LAYOUT OF
 BRIDGES AT STA. 116+26 & STA. 479+16
 HOT SPRINGS-ARIZONA ROAD
 HOT SPRINGS & GARLAND CO.

ROUTE 7 SEC. 546
 ARKANSAS STATE HIGHWAY DEPARTMENT
 LITTLE ROCK, ARK.

DETAILS OF
 WIDENING OF EXISTING ARCH SPAN
 FOR BRIDGE AT STA 116+26
 HOT SPRINGS-ARKADELPHIA ROAD
 HOT SPRINGS, CC
 ROUTE 7 SEC 5

1345
112

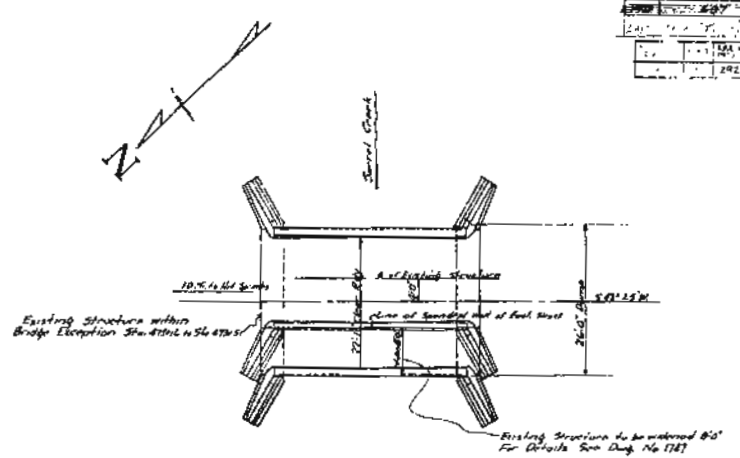
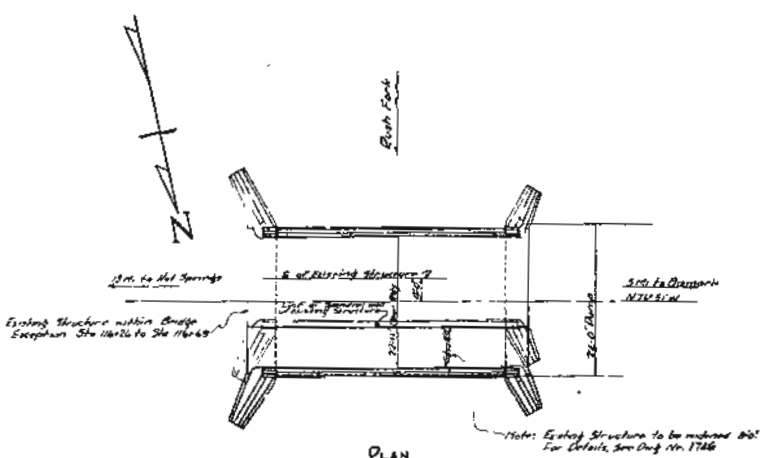
Should be 111?
